Modification P00013

14. DESCRIPTION OF AMENDMENT/MODIFICATION (Organized by UCF section headings, including solicitation/contract subject matter where feasible.) Contract No. N62755-94-D-2902, NAVFAC Specification No. 14-93-2802, Clean Underground Fuel Storage Tanks, Red Hill Fuel Storage Facility, Fleet and Industrial Supply Center, Pearl Harbor, Oahu, Hawaii					
Acceptance of this modification by the contractor constitutes an accord and satisfaction and represents payment in full for both time and money and for any and all costs, impact effect, and for delays and disruptions arising out of, or incidental to, the work as herein revised.					
Modification No. P00013 is continued on page 2.					
Except as provided herein, all terms and conditions of the document referenced in Item 9A or 10A, as heretofore changed, remains unchanged and in full force and effect.					
15A. NAME AND TITLE OF SIGNER (Type or print) Jeffrey M. Bygones, Proc Mgr			16A. NAME AND TITLE OF CONTRACTING OFFICER (Type or print) BRIAN H. SEKIGUCHI, Director Facilities Contract Admin. Division

**To:** David Tourtellott, NAVPET  
**Fax #:** 703-274-9677  
**Re:** PRL 93-17, Clean 9 Red Hill Tanks  
**Date:** Ma

ATLANTIC INDUSTRIAL CONST INC  
US. GOV. # N 62750-01 C 2802  
JOB # 94-7019  
DATE Oct. 18, 1994  
DRAWN BY L FLYNN

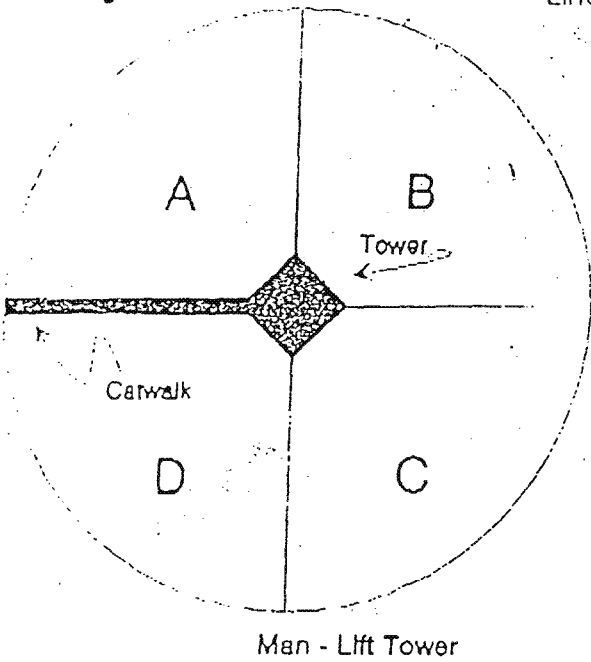
'A'

- 080 WELD APPEARS TO BE LEAKING (0930)
- 090 AREA NEEDS SANDBLASTED AND RECOATING (0936)
- 100 AT LEAST 16 POROSITIES ALONG WELDED DOUBLER PLATE THAT APPEAR TO BE LEAKING (0945)
- 110 DEEP DENT IN TANK SKIN (0958)
- 120 POROSITY IN WELD BELOW ADJ RING APPEARS TO LEAK (1005)
- 130 FOUND BROKEN BLISTER IN COATING APPEARS TO HAVE BEEN CAUSED BY CORROSION FROM BACKSIDE OF TANK SKIN. HOLE IN TANK SKIN LOCATED BY PROBE. (1009)
- 140 LARGE DEEP DOUBLE DENT IN TANK SKIN - U/T (1015)
- 150 POROSITY IN WELD APPEARS TO BE LEAKING (1016)
- 160 3 POROSITIES FOUND IN WELD BELOW STIFFENER LEAKING (1022)
- 170 2 BLISTERS UNBROKEN SAME AS 130 (1023)
- 230 RECOAT
- 240 RECOAT (BASKET DAMAGE)
- 280 FAULTY COATING - RECOAT (1345)
- 290 FAULTY COATING - RECOAT (1351)
- 300 APPEARS TO BE BLISTER TOP OF PLATE #8 DIRECTLY UNDER CATWALK

# Red Hill Tank Farm - Tank #12 - First Course Layout

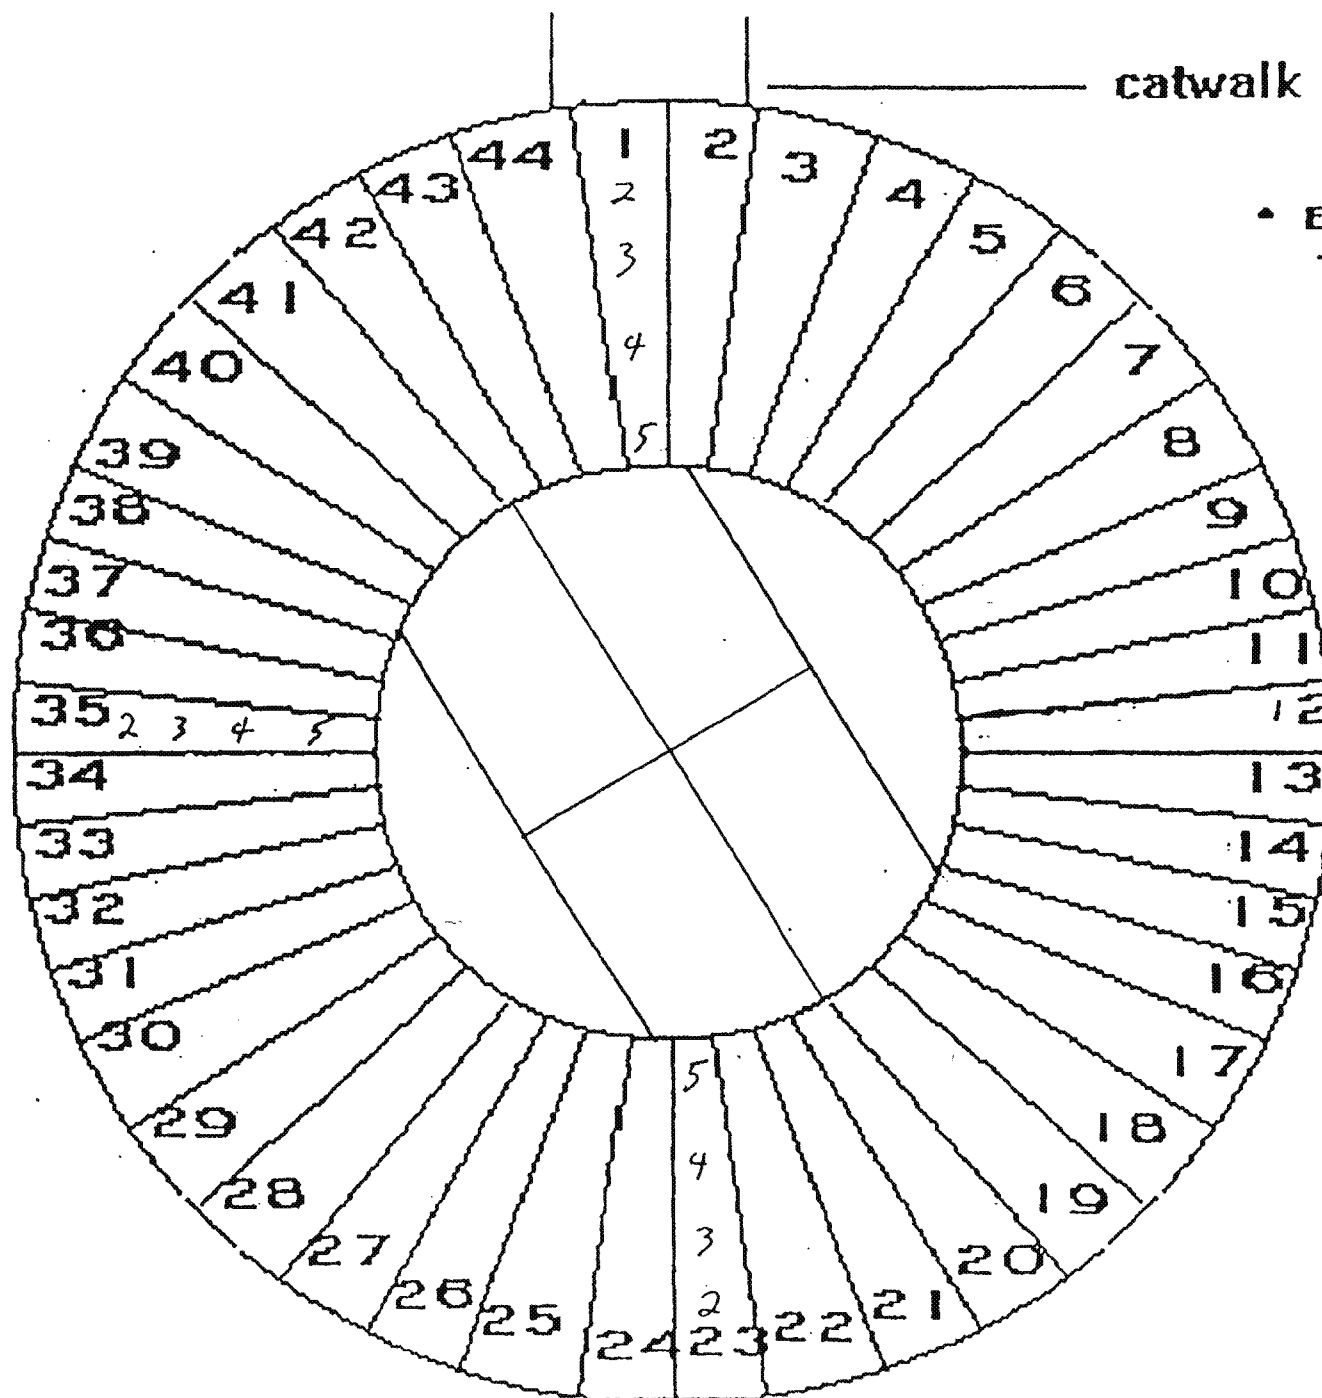
Red Hill  
 tank #12  
 floor VT

red Hall  
tank #12  
Areas of  
Coating removal

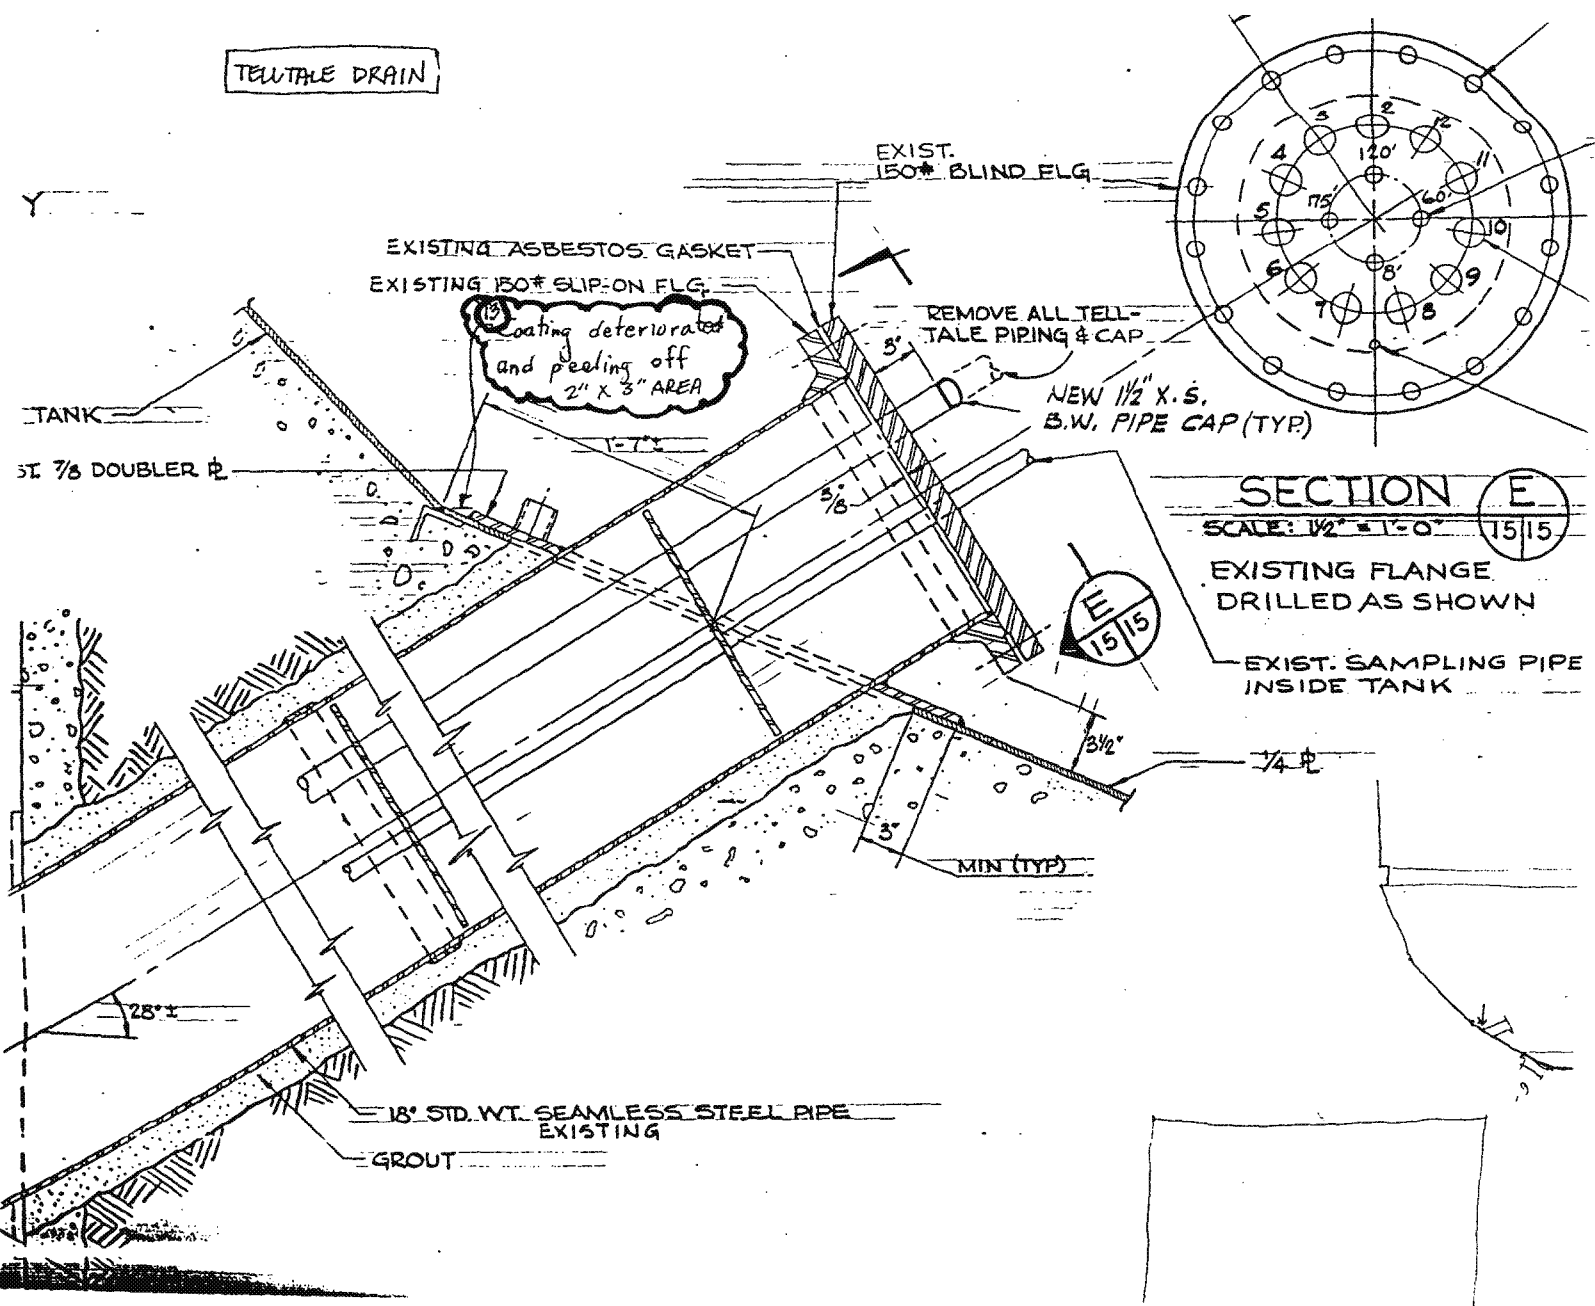
### Discrepancies in Tank #12

<u>Discrepancy</u>	<u>Action Required</u>
1. Pit, 0.80", coated	No action required
2. Dent, 0.105", uncoated no rust	Regauge dent depth, Ultrasonically test plate at bottom of dent, Recoat with epoxy
3. Double-pitted dent, 0.200" uncoated	Regauge dent depth, Ultrasonically test plate at bottom of dent, Recoat with epoxy
4. Three pits, 0.045", uncoated	Recoat with epoxy
5. Four broken blisters, uncoated	Recoat with epoxy
6. One broken blister, uncoated	Recoat with epoxy
7. Two pits, 0.037" and 0.045",	No action required
8. One broken blister, uncoated	Recoat with epoxy
9. Pit, 0.021", uncoated	Recoat with epoxy
10. One broken blister, uncoated	Recoat with epoxy
11. Pit, 0.070", 1" long, coated	No action required
12. Pit, 0.070", coated	No action required
13. Uncoated area approx. 2"x3"	Recoat with epoxy
